WCHS Track and Field: Change Order #04 Summary

| DATE: | 10/17/2024 | PR #: | PR 006 |
| TO: | Clay Ratliff – Trace Creek Construction | RE: | Woodford County Board of Education Versailles, Kentucky BG 19-353 RTA 1916 Phase 2 |

E1.2

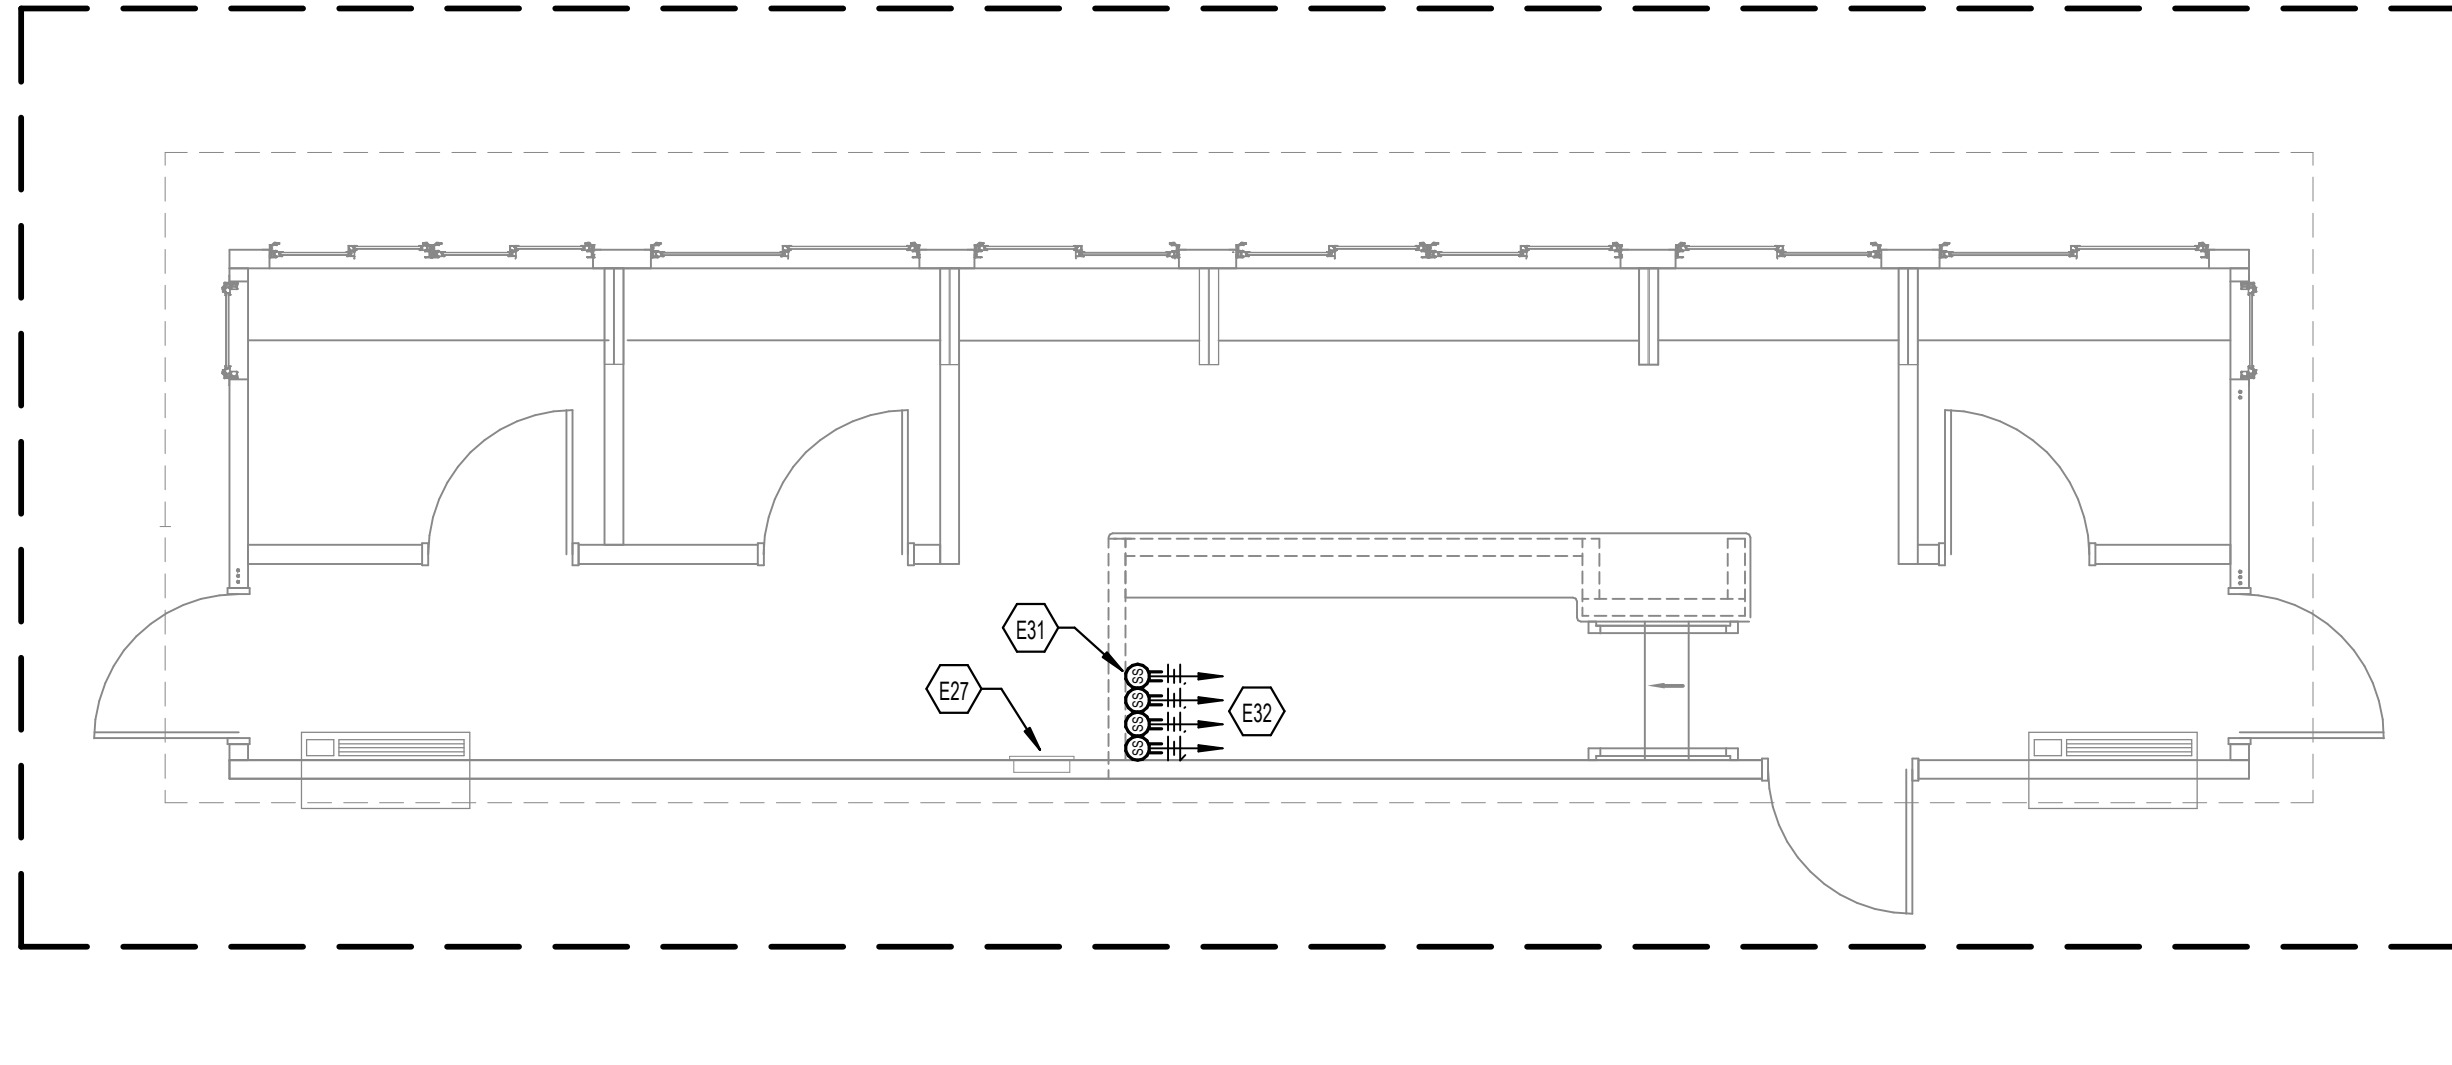
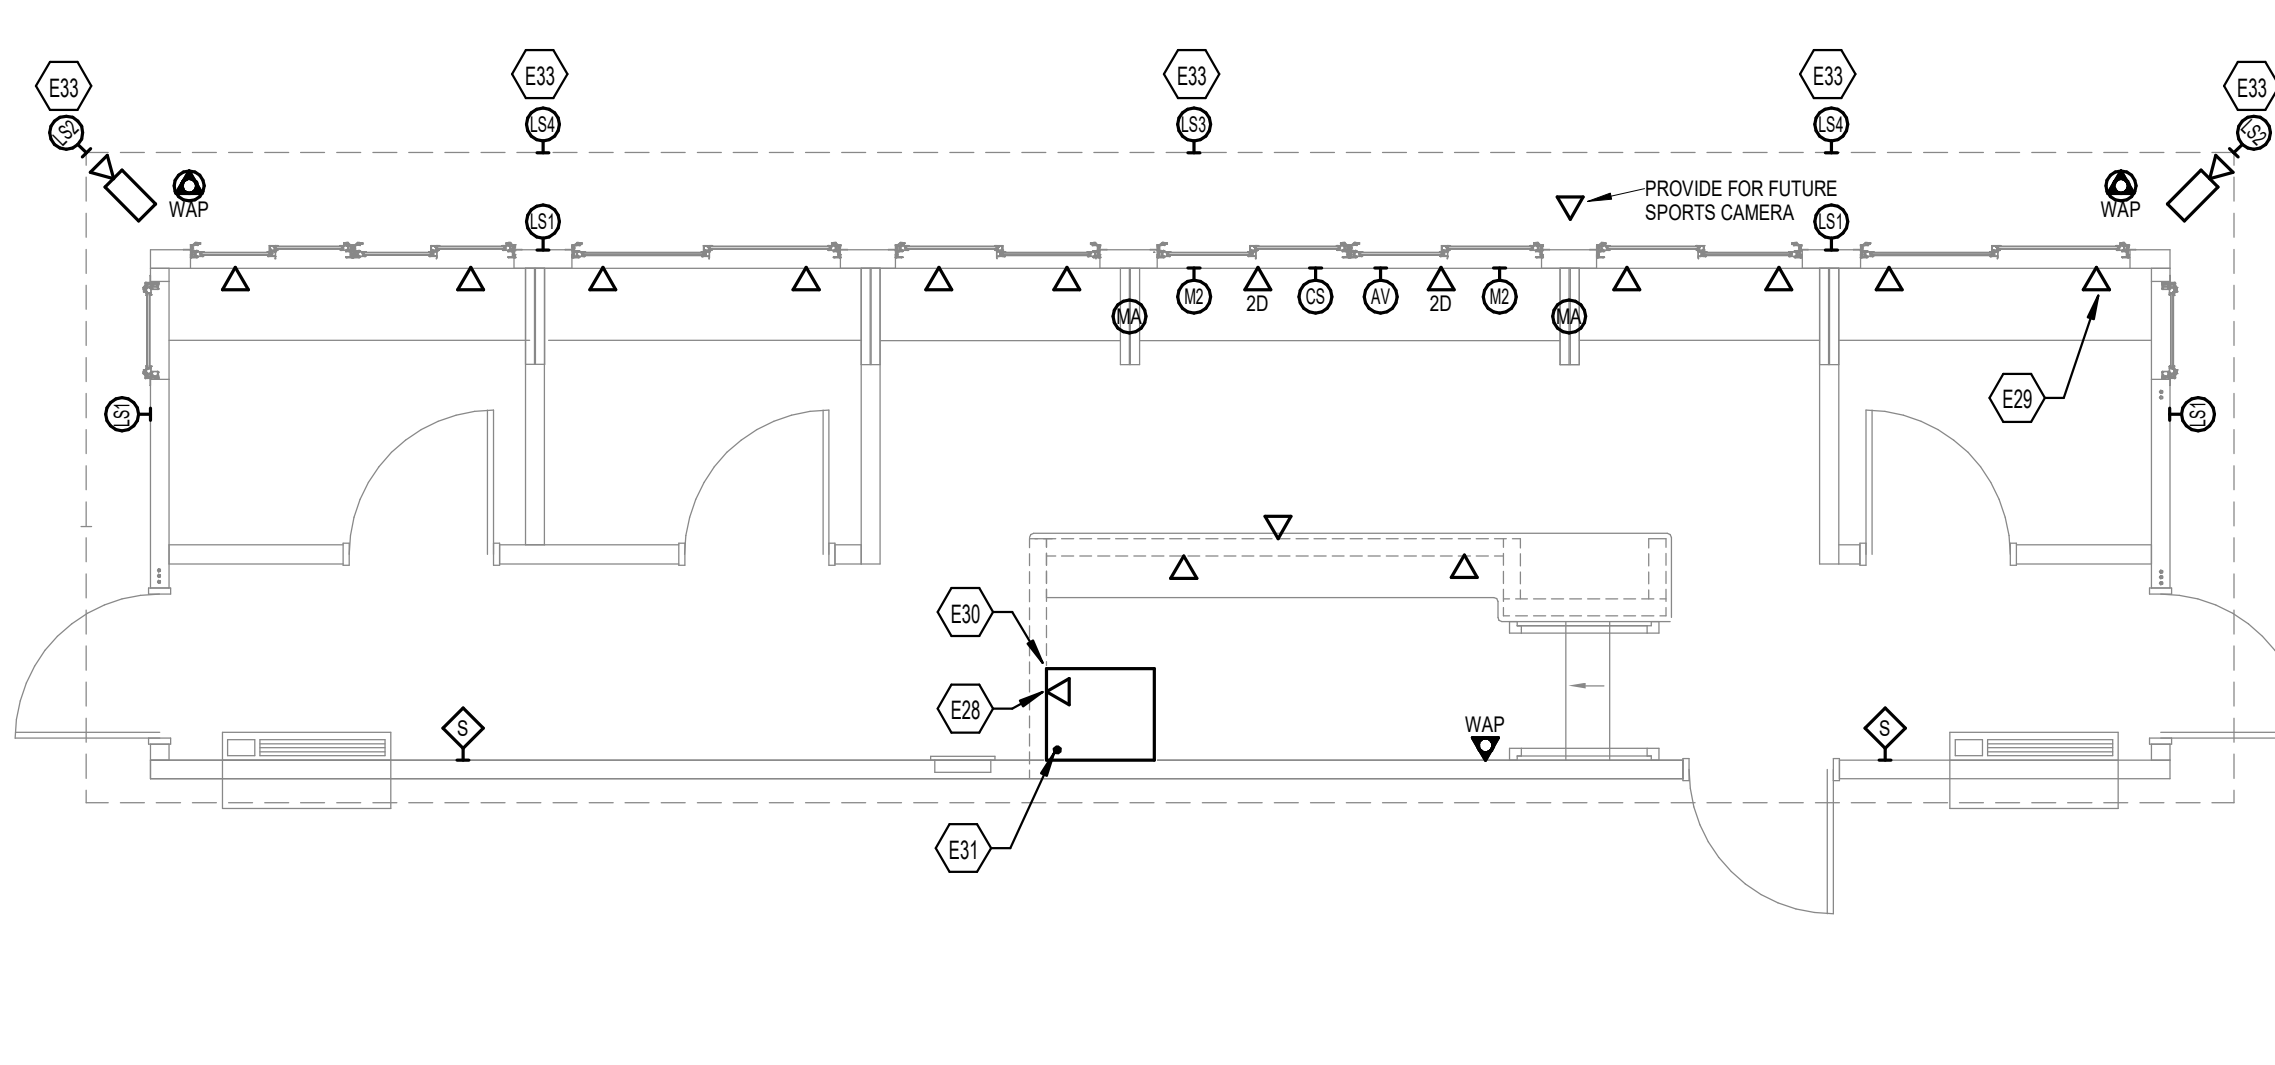
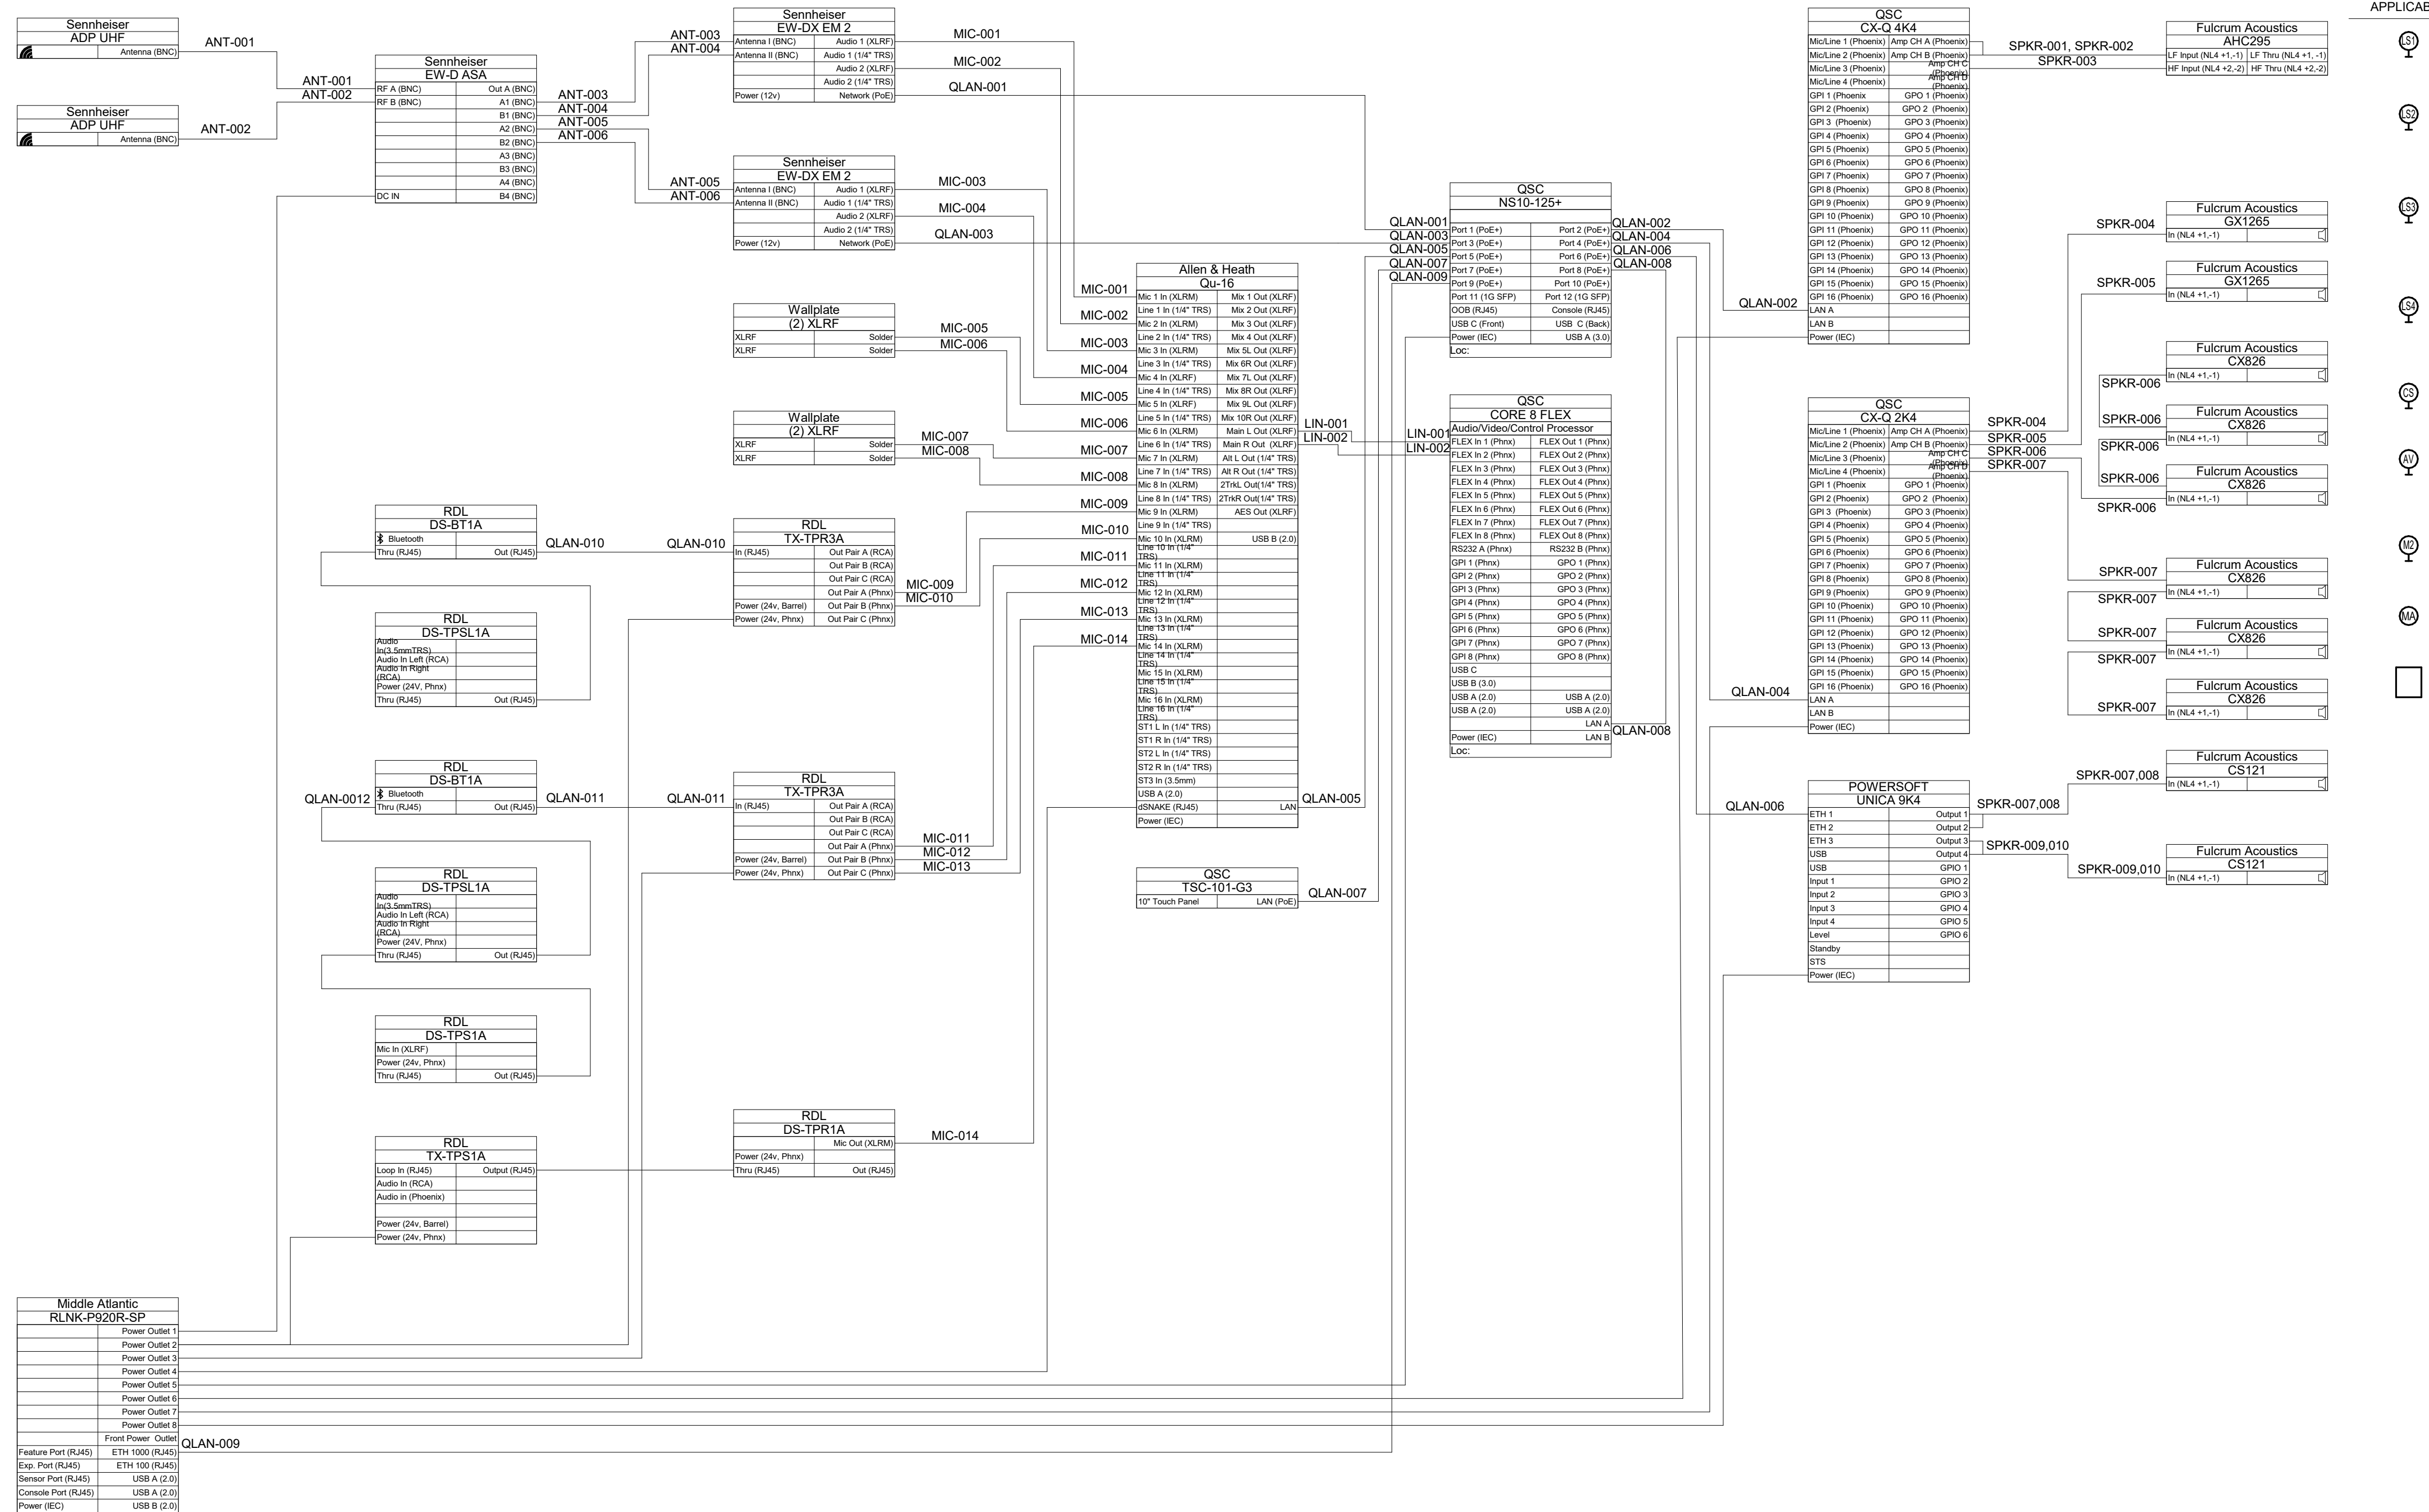
7. Add devices and equipment per E1.2 pressbox plans.
8. Add electrical equipment to support pressbox and videoboard per E2.0 one-line diagram.
9. Add pressbox communication riser and modify fiber one-line diagram to support pressbox and videoboard.
10. Provide a separate price to perform the following work: Upgrade athletic field lighting system to be 50FC.
